Synthetic Review Drawing Stub

Part	Adjustable carton magazine side guide plate
Revision	B
Pilot	WEBASTO
Material	Stainless steel

Views

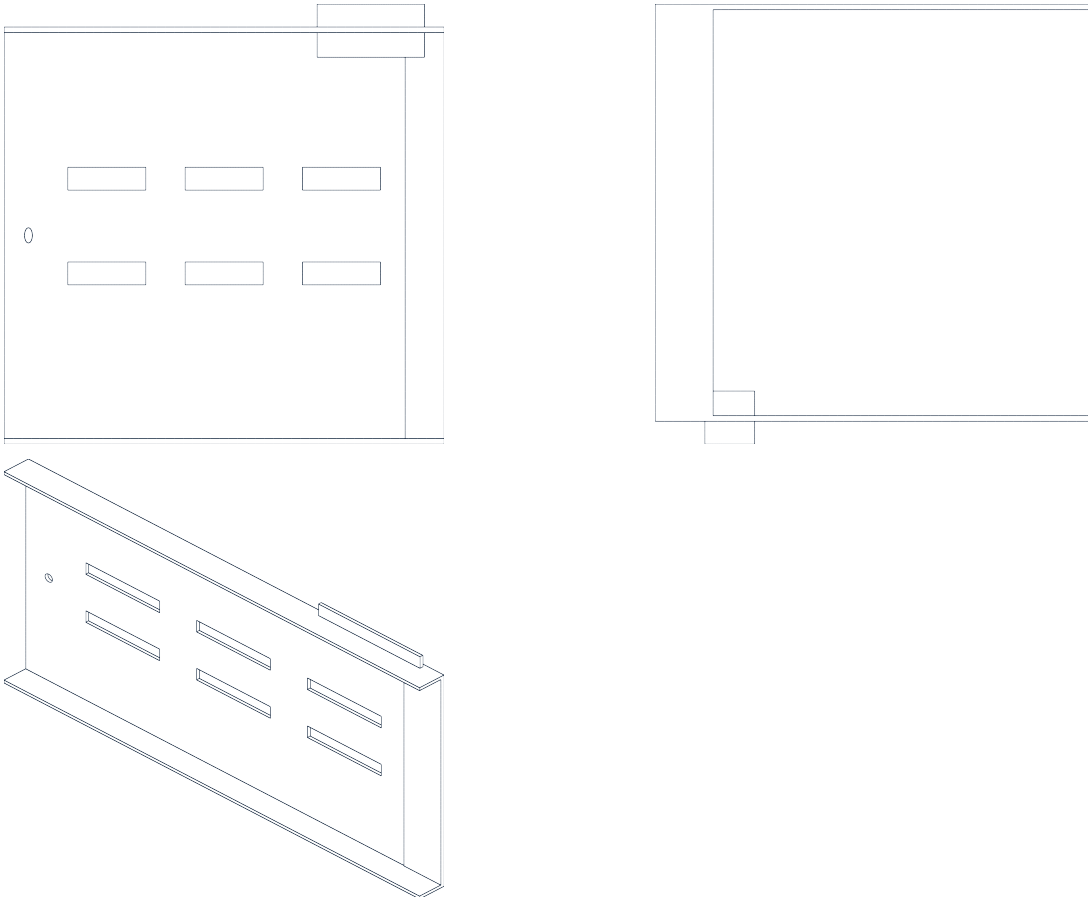
- Lengthen the primary adjustment slots by 20 mm.
- Add a second slot row for wider changeover range.
- Fuse in a local doubler patch to stiffen the revised flange area.
